ADMINISTRATION BULLETIN

Accelerator Pedal Alignment –
Check/Replace Accelerator Pedal Assembly –
Recall Action R847

MODEL 2006 MY
XK Range
VIN See VIN list

TECHNICAL BULLETIN

ILLUSTRATION 1

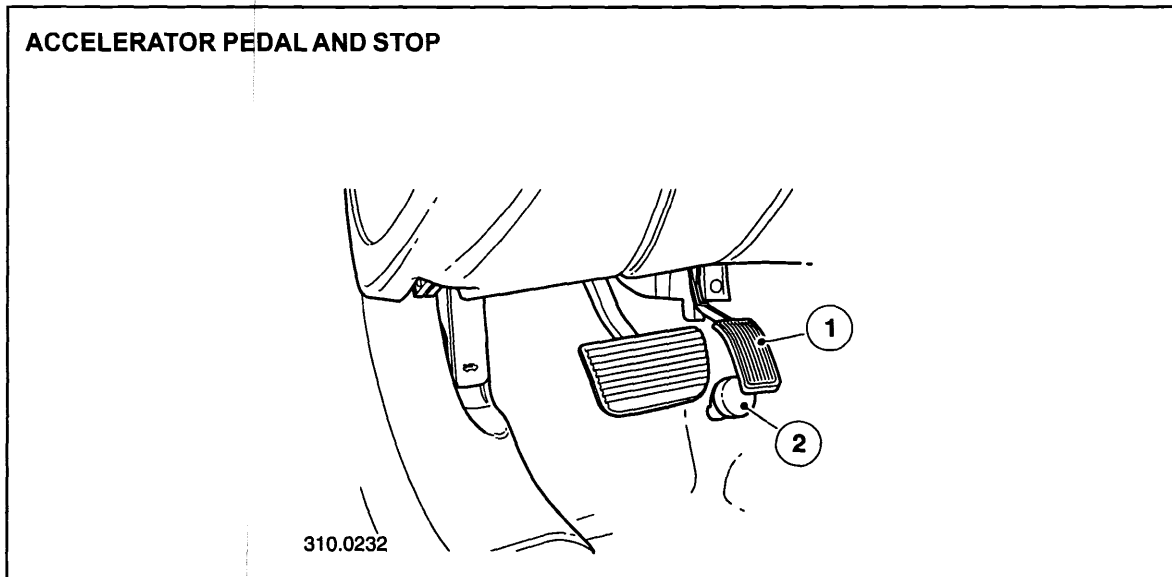
Check the alignment of the accelerator pedal (item 1 of Illustration 1) and the throttle stop (item 2 of Illustration 1).

1. Depress the accelerator pedal to contact the throttle stop.

ILLUSTRATION 2

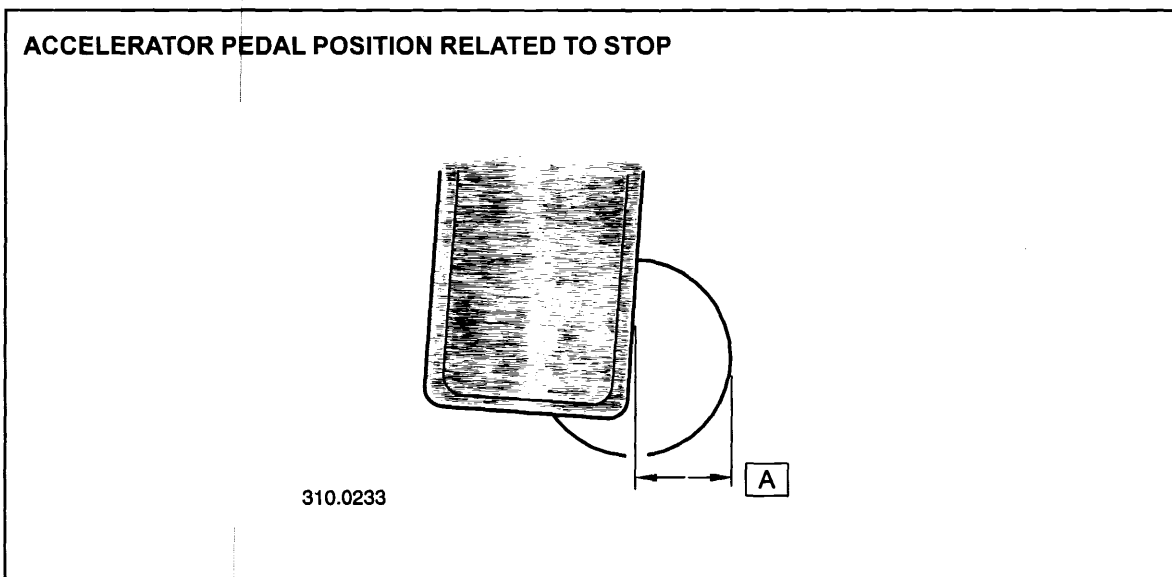
Note: The accelerator pedal should cover a minimum of half the throttle stop laterally (measuring across the center) leaving a maximum of 20 mm (A, Illustration 2) of exposed throttle stop.

2. If the measurement is 20 mm or less, torque the accelerator pedal assembly fixings

to 9 Nm (6.6 lb-ft); no further action is required.

ILLUSTRATION 3

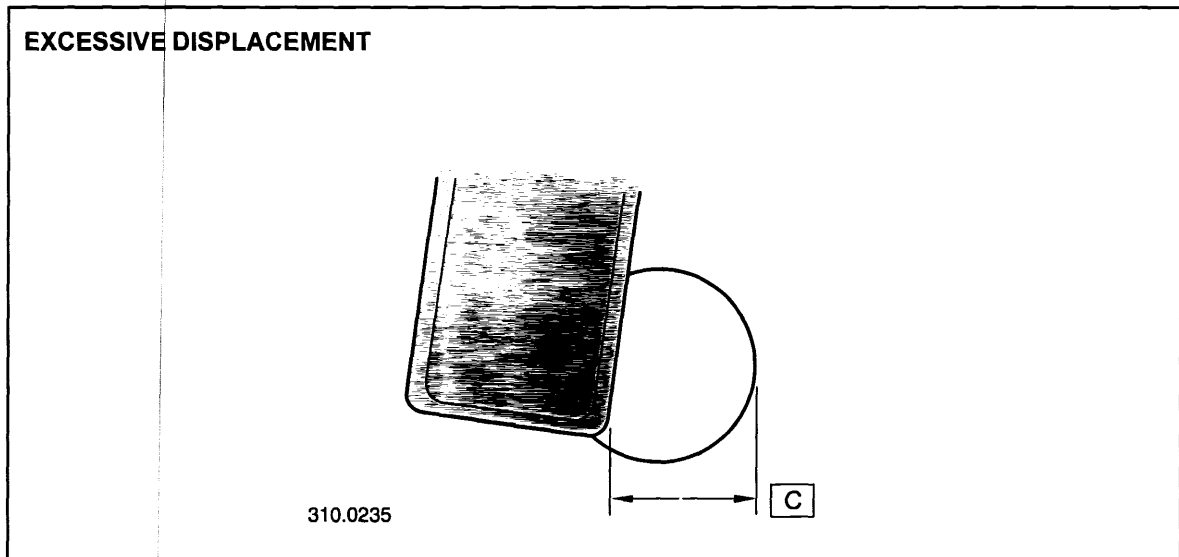
3. If the measurement is greater than 20 mm (C, Illustration 3), remove the accelerator pedal assembly. Refer to Global Technical Reference (GTR), Workshop Manual, section 310-02.

4. Remove the throttle stop and locating stud from the removed accelerator pedal assembly and install it on the new accelerator pedal assembly, part number JLM 21753.
5. If the accelerator pedal pad is aluminum, remove the aluminum pedal pad from the removed pedal assembly and install it on the new pedal assembly.
6. Install the new accelerator pedal assembly, refer to Global Technical Reference (GTR), Workshop Manual, section 310-02.

ILLUSTRATION 1

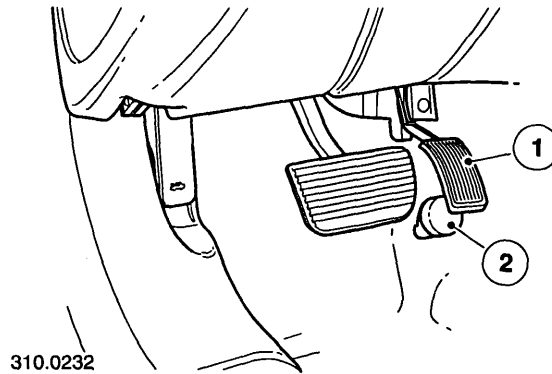
Check the alignment of the accelerator pedal (item 1 of Illustration 1) and the throttle stop (item 2 of Illustration 1).

1. Depress the accelerator pedal to contact the throttle stop.

ILLUSTRATION 2

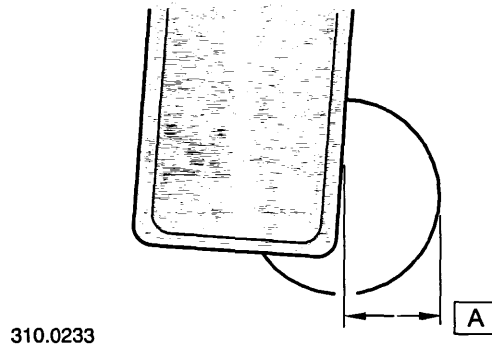
Note: The accelerator pedal should cover a minimum of half the throttle stop laterally (measuring across the center) leaving a maximum of 20 mm (A, Illustration 2) of exposed throttle stop.

2. If the measurement is 20 mm or less, torque the accelerator pedal assembly fixings to 9 Nm (6.6 lb-ft); no further action is required.
3. If the measurement is greater than 20 mm (C, Illustration 3), remove the accelerator pedal assembly. Refer to Global Technical Reference (GTR), Workshop Manual, section 310-02.
